SSD 6624 - Proposed Slys Quarry Expansion Additional Response to Submissions

This letter provides a response to the Office of Environment (OEH) biodiversity comments from their letter dated 24 June 2015 and to your email dated 02 December 2015.

Figure 1 Predicted operational noise levels – Peak daily production with rock hammer (worst case scenario)

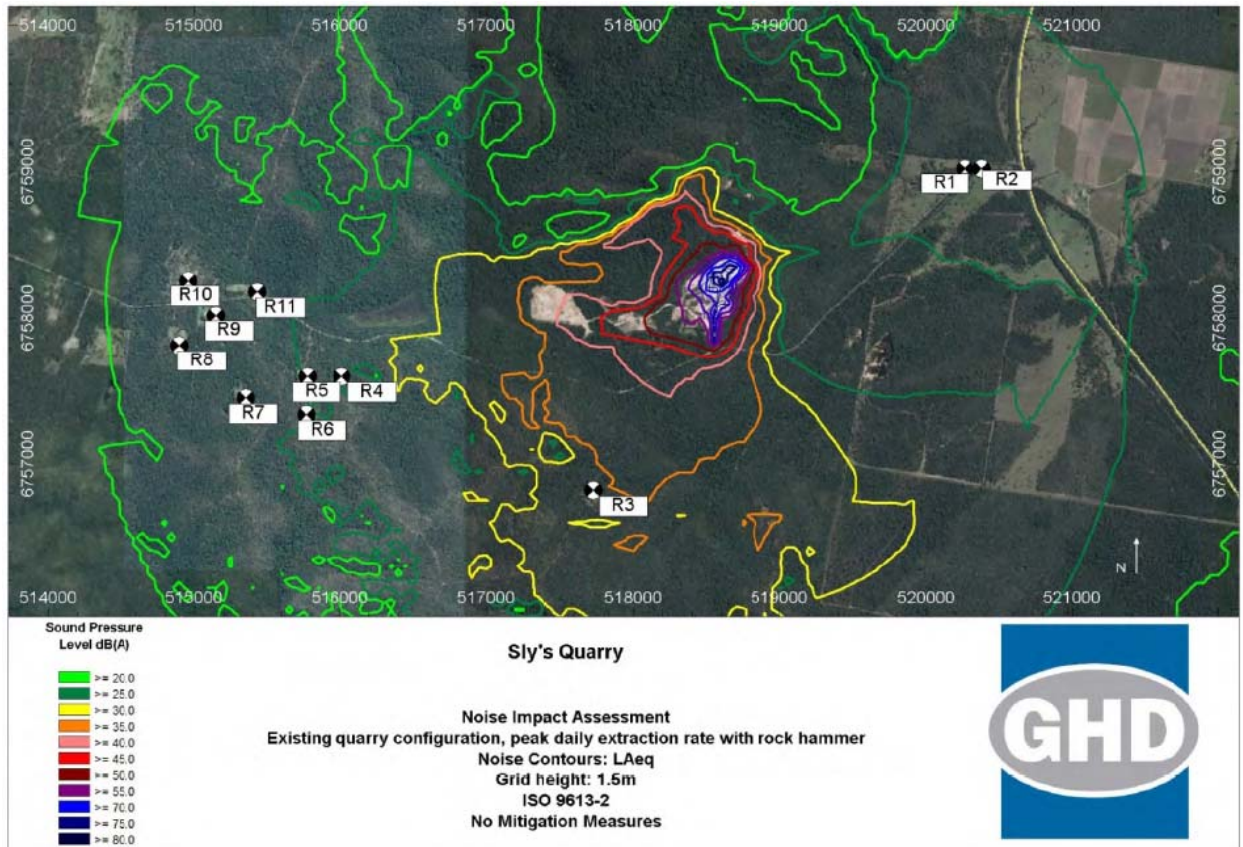
The location of the proposed dwelling is unknown, however, based on the background monitoring done for the *Noise Impact Assessment*, the likely noise criteria for it would be 35dB(A). As shown on Figure 1, the 35dB(A) contour (orange line) does not extend onto Mr Hills’ property. While noise from the quarry may be experienced by Mr Hill, the *Noise Impact Assessment* indicates it will be within the relevant criteria.

As further reassurance, if the proposal is approved, it is likely there will be a requirement for compliance monitoring, as recommended in the *Noise Impact Assessment*, which would confirm if the noise criteria is achieved.
